**Re: PETITION NO. 1426 – DG Connecticut Solar, III, LLC petition for a declaratory ruling, pursuant to Connecticut General Statutes §4-176 and §16-50k, for the proposed construction, maintenance and operation of a 4.9-megawatt AC solar photovoltaic electric generating facility located west of the Ellington town boundary at 341 East Road, East Windsor, Connecticut and associated electrical interconnection.**

Subject: Solar One East Windsor – Sound control - Acoustical engineering design study

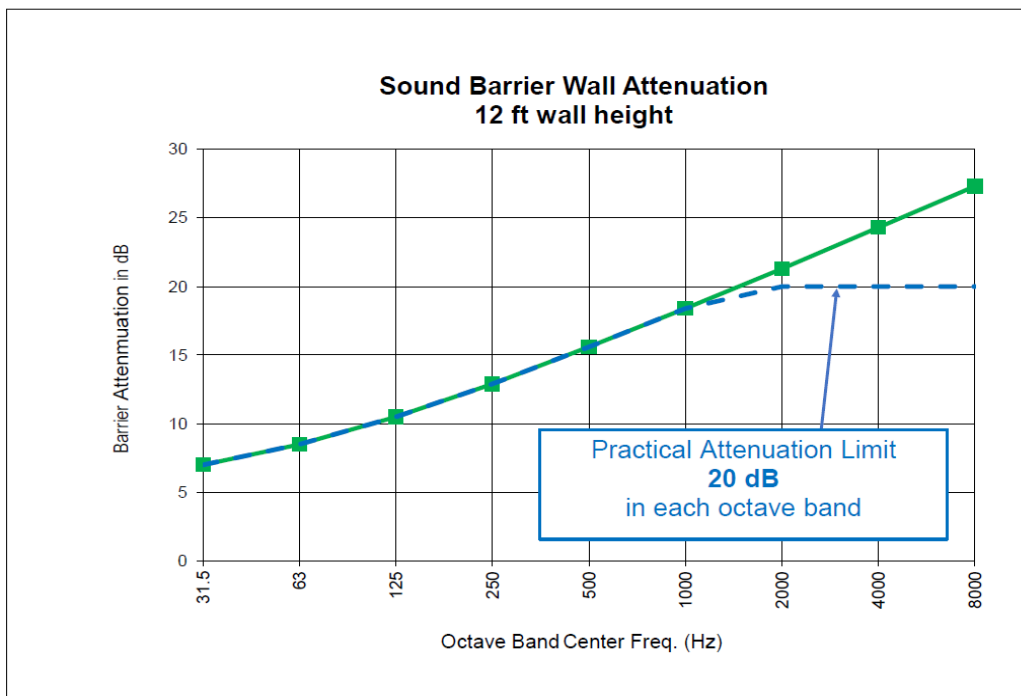
The sound control design features a sound barrier block wall, 12 feet high and located 5 feet to the north of the power inverter banks, between those power inverter banks and the nearby residences. The barrier wall shall be sized appropriately to comfortably intervene between the inverter bank at the facility and the neighbor residences to the north, allowing room for routine maintenance and for cooling air to circulate. A conceptual sketch of the wall in position to the north of the solar power inverter banks is shown below.

The sound barrier wall shall be constructed of 16 inch cinder blocks, of standard dimensions (16x8x8 inch), which have a weight of at least 28 pounds per piece. The wall shall be laid in courses 16 inches thick. This yields a face weight for the wall of about 63 pounds per square foot.

The barrier wall design shall be compatible with structural engineering best practices for sustaining wind loads, and frost heaves for the existing soil conditions. The wall shall be set on proper footings prepared in accordance with the State of CT Building code. Vertical and horizontal steel reinforcement bars shall be placed in accordance with the State of CT Building Code and best practices. Support buttresses shall extend northward from the wall at regular intervals. The sound barrier wall and buttresses shall be grouted or filled with sand as needed to support the reinforcement bars, per best practices, and shall be capped with weather resistant capstone blocks.

No holes, penetrations or gaps shall be allowed in the sound barrier wall which allow sound to escape through the wall to the north side of the wall. Gravel shall be installed in the footing trench around the barrier wall to allow for drainage, per structural engineering best practices.

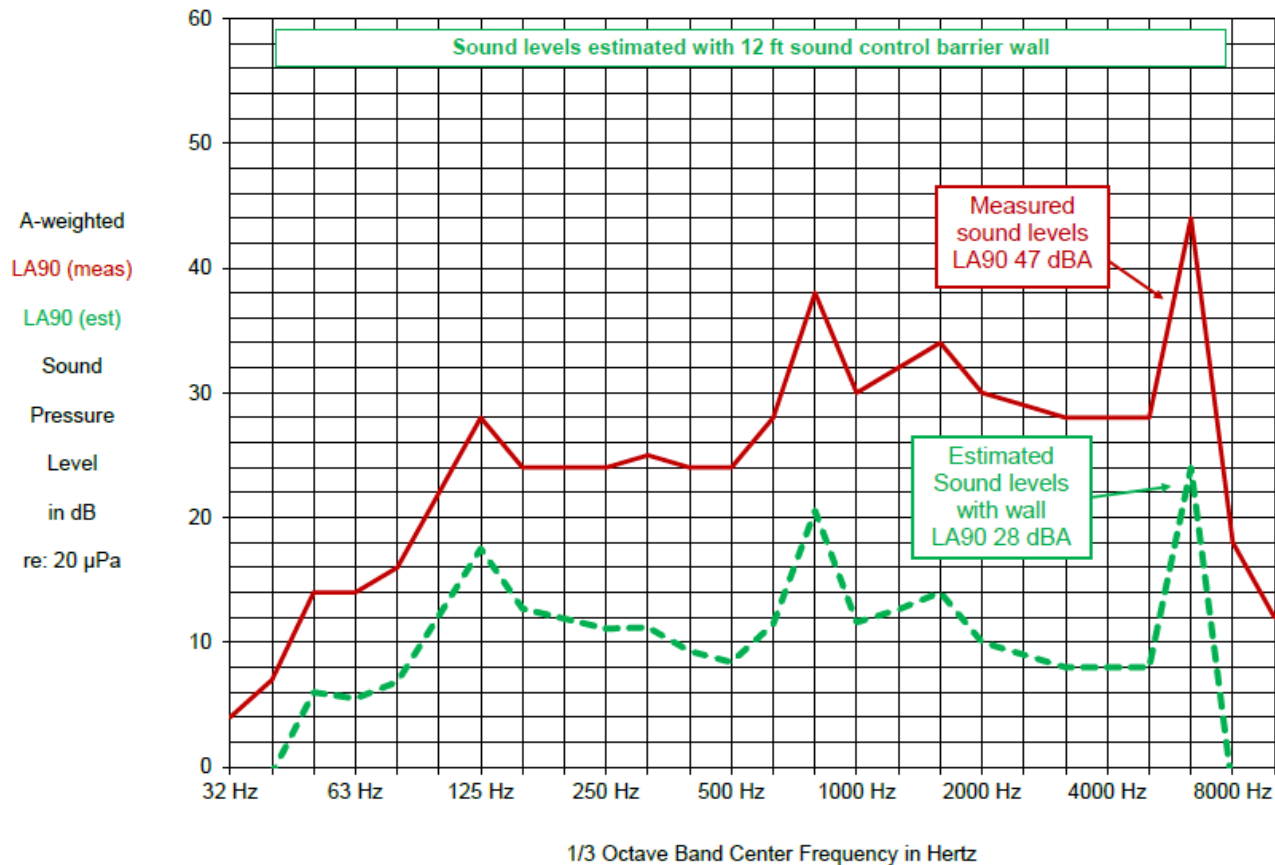
It was determined that a 12 foot wall would provide the best sound attenuation for a realistic wall. A graph which shows the calculated sound attenuation for the 12 foot high wall is shown below. Note that the practical limit for sound attenuation provided by a wall that is open to the sky is 20 dB in each octave band.

As seen in the barrier acoustical calculations (above), the amount of sound reduction provided by the sound barrier wall increases with increasing frequency, until it reaches a practical maximum of about 20 dB in the higher frequency bands.

The calculated practical limit sound attenuation values for the 12 foot wall were applied to the measured sound spectrum at the nearest residential property line to the solar power inverters.
